DATE 12/94
Amended 6/96

TECHNICAL BULLETIN

Positive Start Cable –
Reroute –
Service Action S629

MODEL 1995 MY
XJR Sedan
VIN 720125-745782

ILLUSTRATION 1

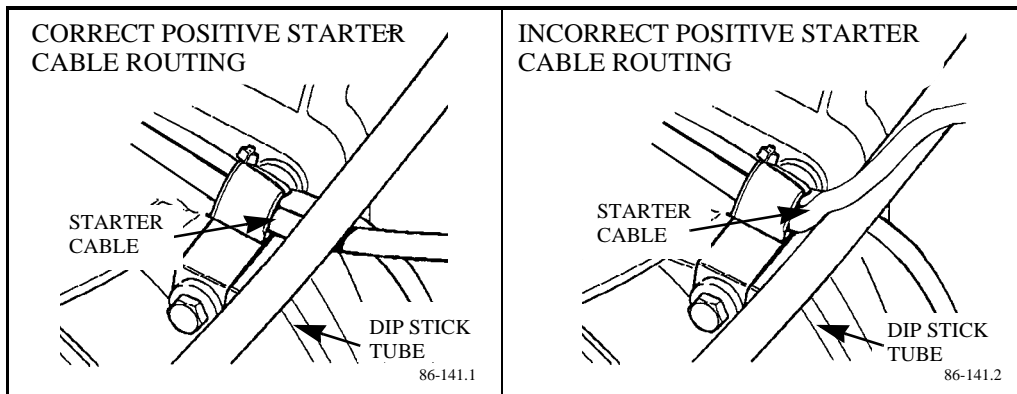
The positive starter cable may be incorrectly routed in 1995 MY XJR Sedan vehicles from VIN 720125 - 745782.

The CORRECT routing of the positive starter cable is shown in Illustration 1. (Starter cable routed BELOW the automatic transmission dipstick tube.

The INCORRECT routing of the starter cable is shown in Illustration 2. (Starter cable routed ABOVE the automatic transmission dipstick tube)

If the positive starter cable is incorrectly routed, reroute following the procedure described below.

1. Disconnect the battery negative cable.
2. Remove the positive starter cable from the right side firewall stud.
3. Reroute the starter cable from above the automatic transmission dip stick tube (Illustration 2) to below the automatic transmission dipstick tube (Illustration 1).

4. Reconnect the starter cable to the firewall stud and reposition the rubber boot.
5. Reconnect the battery and the clock.
